Response to Outstanding Matters for PDA Development Application for a Development Permit for Reconfiguring a Lot (DEV2025/1676) at 4745–4759 and 4761–4773 Mount Lindesay Highway, North Maclean

On behalf of *Roubaix Properties Pty Ltd* ('The Applicant') please find below a full response to the outstanding matters requested by the Minister for Economic Development Queensland ('EDQ') on 6 May 2026 for the development application at 4745–4759 and 4761–4773 Mount Lindesay Highway, North Maclean QLD 4280 formally described as Lot 7 and 8 on RP137101 (EDQ Ref: DEV2025/1676).

Figure 1 – Overall Layout Plan with overlay of impacted vegetation and 50m buffer

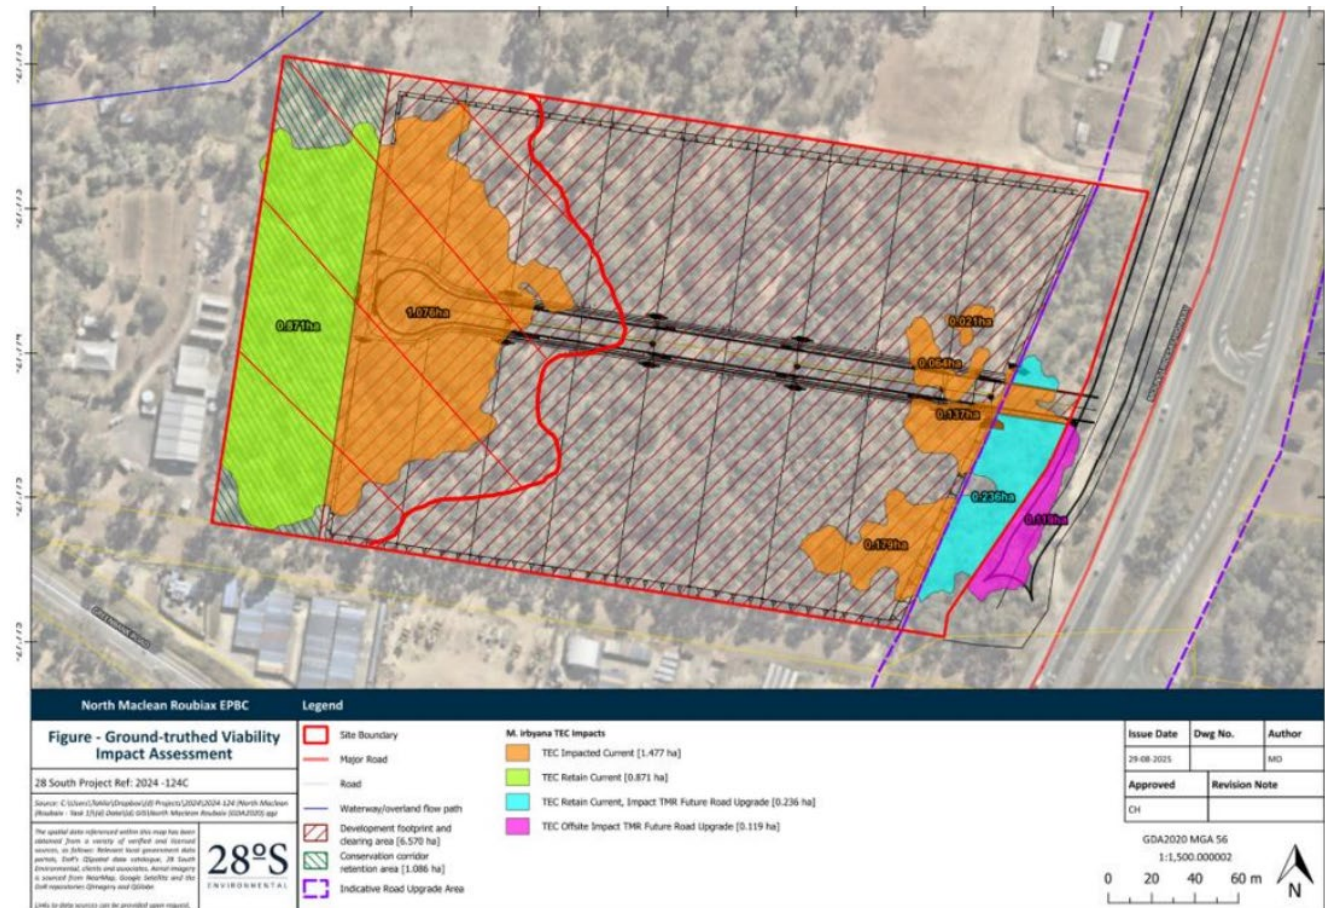
Provide amended subdivision plans, including a change to the cul-de-sac location in the Industrial Access Street, removing lots at the western end of the site identified as containing ground-truthed impacted vegetation plus a 50m protection buffer.

Any approval will be subject to conditions to prevent development occurring on the part of the site shown within the dashed red box in **Figure 1** below.

In response to Item 1, the Applicant has amended the proposed subdivision layout to provide additional land for flood storage and conveyance, however, maintains the 50-metre environmental buffer along the western boundary, which will be protected via proposed covenants as shown in **Attachment B**.

At the outset, the Applicant reiterates that it does not consider the extent of the requested retention area identified in **Figure 1** to be justified, reasonable or necessary having regard to the site's existing and historical

In this regard, the Applicant maintains the view that the removal of lots as provided in **Figure 1** is not necessary or proportionate to address ecological considerations relevant to this site under the relevant planning framework. The Applicant considers that such changes would unnecessarily constrain the development outcome and would be inconsistent with the purpose and intent of the development scheme and the *Economic Development Act 2012* (the Act).

The Applicant retains the 50-metre ecological corridor proposed along the western boundary in the site design as previously requested by EDQ. A covenant is proposed over proposed Lot 1 and 9 to ensure these ecological values are retained and maintained in perpetuity.
